Independent Hearing Commissioners

Date of Report: 6 November 2020

Applicant: Wairoa District Council
Activity Type: Discretionary (when bundled)
Notification Type: Publicly Notified (requested by applicant)
Authorisation Numbers and Activities: See Table 1 (below)

Figure 1: Change in flow conditions with upgrades

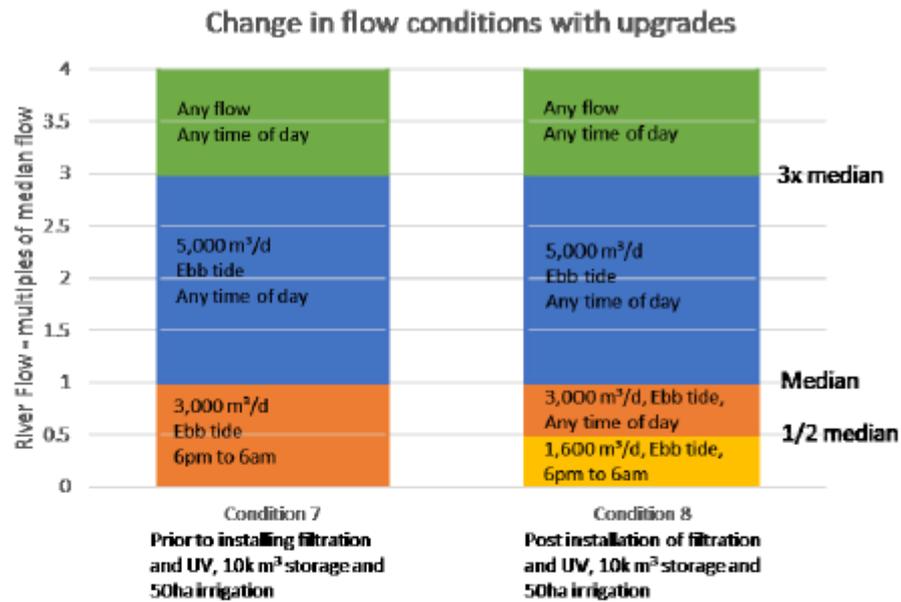
The diagram below highlights that the change in discharge flow conditions will allow increased contact of treated wastewater with recreational users (between ½ median and median river flows), and therefore requires conditions that ensure improved pathogen removal.

Given the consent’s intent, and the above requirements that define the need for filtration and UV system, it is not unreasonable to include conditions that measure the effectiveness of the system, both after installation, and into the future – ensuring effective operation and maintenance.

Figure 2: Lower Limit Breaches of greater than 8 times per Condition for Ammonia

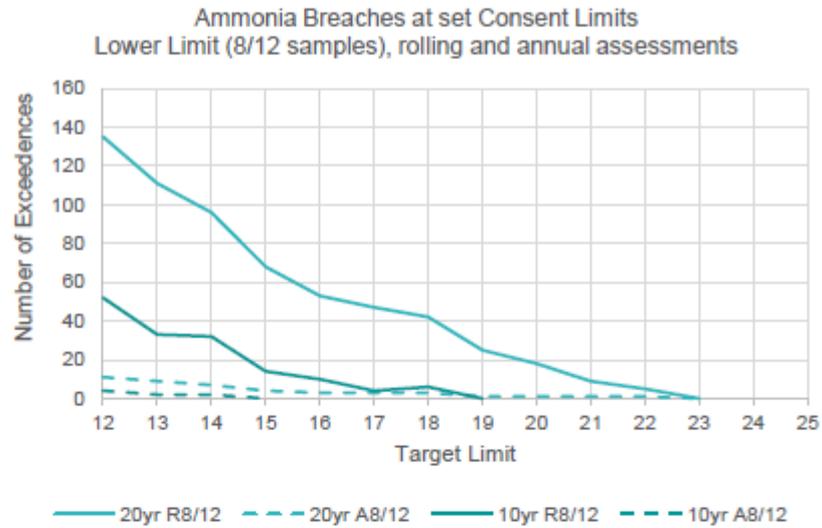
The graphs show the number of times the limit is exceeded by greater than the number allowed in the condition (i.e. more than eight of two times respectively). Where the curves meet zero, provides the limit which could have been achieved consistently for the 10 or 20 year period if the curve. The solid lines show rolling average calculations, and the dashed lines show an annual assessment of data (January to December).

Given the reporting requirements, we can support an annual assessment of the discharge against limits, but will require lower limits to represent actual past performance (over the past decade). The recommended limits are therefore provided below.

Ammonia Breaches at set Consent Limits
Lower Limit (8/12 samples), rolling and annual assessments

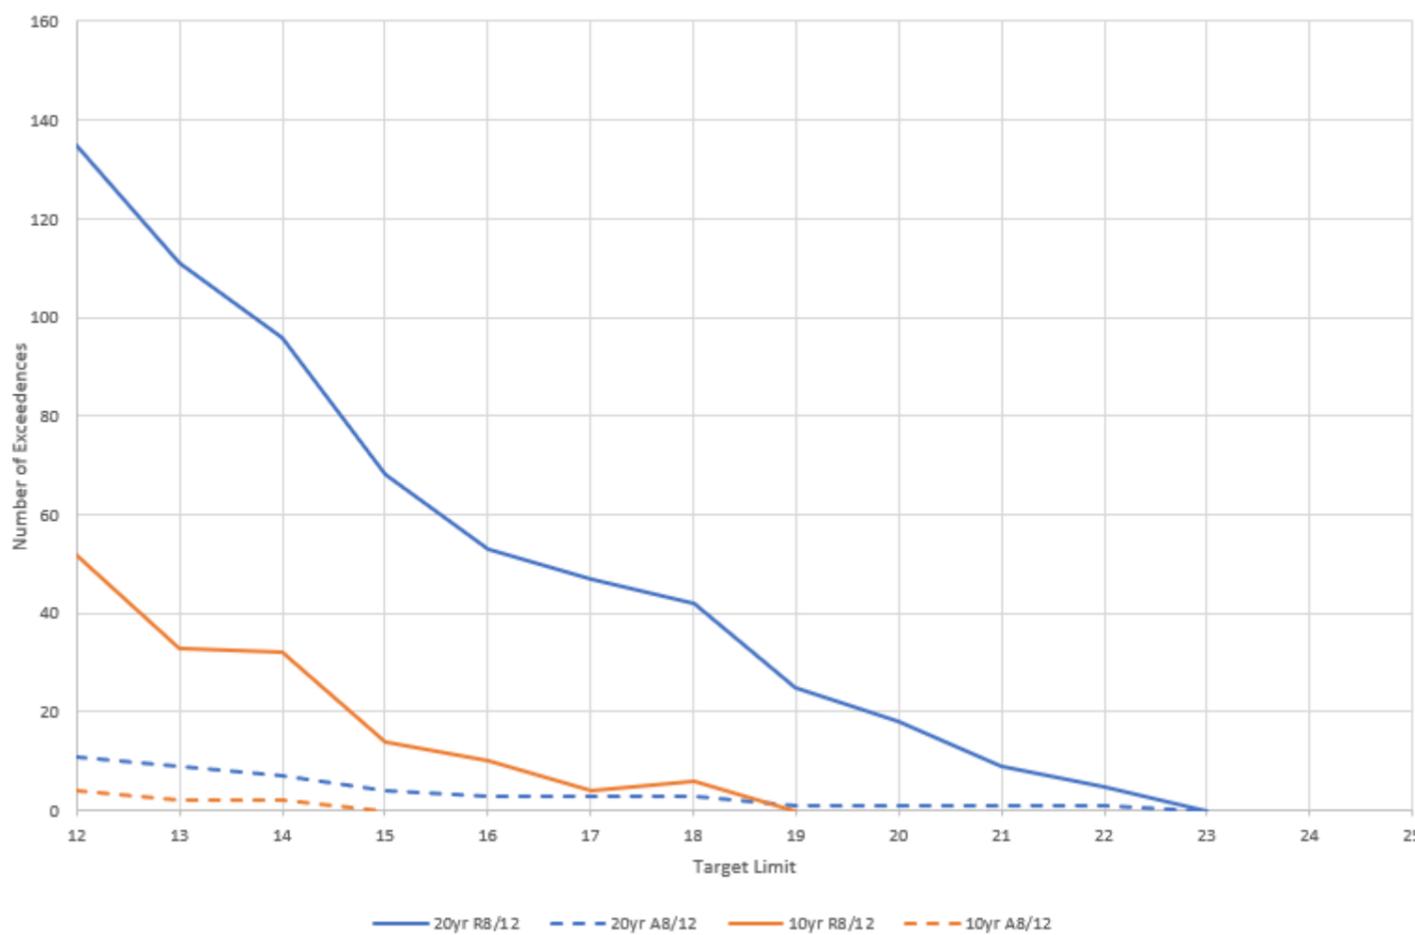
Proposed Values for Annual Assessment							
Parameter	Previous Consent	Proposed by WDC		Proposed revised values			
	Max	8/12	2/12	8/12	Median	2/12	
Ammonia	36	25	40	15	18	27	
oBOD ₅	-	25	75	21	29	61	
COD	220	-	-	158	164	300	
TSS	87	70	150	50	77	118	
E.coli	-	20,000	200,000	5,500	12,000	75,000	
Enterococci	-	10,000	100,000	3,200	5,200	34,000	
UVT	-	-	-	54	57	65
